Title: **HPR153F, HPR153i, HPR122i compression drivers**  
 Bulletin #: HPR0003 Issue Date: October 21, 2008  
 Models Affected: HPR122i, HPR153i, HPR153F Bulletin Revision: Rev. D  
 Production Range: All HPR153F; HPR122i prior to serial number GJ8330251;  
 HPR153i prior to serial number GJ8360009. (See serial number  
 date code guide on next page.)

## Description

Figure 2. HPR153i assembly/disassembly.

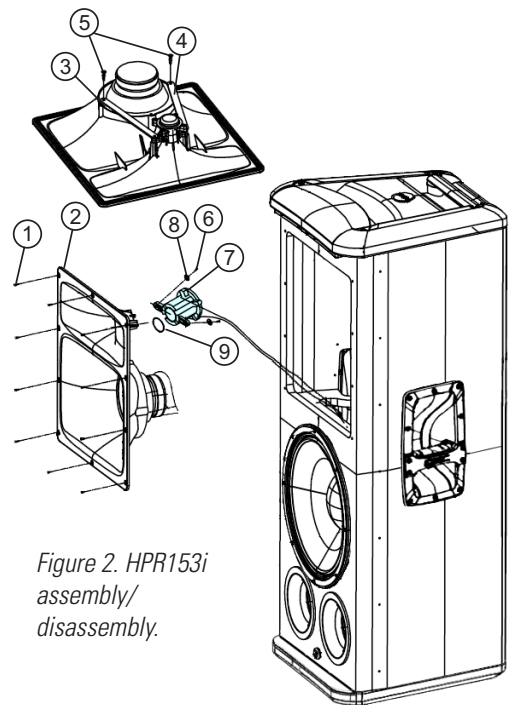
See Figure 2 (for the HPR153i) or Figure 3 (HPR122i).

3. Remove the screws ① that secure the waveguide ② to the enclosure. There are 10 screws on the HPR153i and four on the HPR122i.
4. Carefully lift the waveguide from the enclosure. There will be wires attached to the drivers, so also be careful to not strain them.
5. Disconnect the wires from the compression driver terminals and cut away any tie wraps that may have been used to secure the wires to the driver for strain relief. Note that the purple wire was connected to the + terminal, and the black wire to the - one. When it is time for reassembly, the new driver will connect the same way.
6. On the HPR153i, remove the support bars ③ and ④ from the compression driver. Set the screws ⑤ aside.
7. Remove the screws ⑥ that secure the compression driver ⑦ to the

- Detach the compression driver from the waveguide. Remove the gasket ⑨ from between the driver and the waveguide. Discard the old driver.

- Place the gasket on the throat of the waveguide and set the new compression driver in place on it. Attach the driver to the waveguide using the screws ⑤ and washers ⑧. Tighten the screws securely but do not overtighten them.
- On the HPR153i, apply threadlocking compound to the screws ⑤ and reattach the support bars on the compression and midrange drivers. Tighten the screws securely but do not overtighten them.
- Reattach the wires to the compression driver terminals (purple to +, black to -). With the tie wrap, secure the wires to the body of the compression driver so the connections do not have excessive strain (Figure 4). After you tighten the tie wrap fully, cut off the excess length.
- Reattach the waveguide to the enclosure. Tighten the screws in a crisscross pattern.

Figure 3. HPR122i assembly/disassembly.

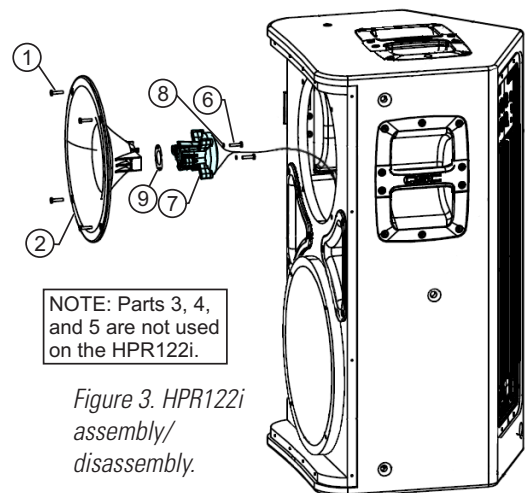
NOTE: Parts 3, 4, and 5 are not used on the HPR122i.
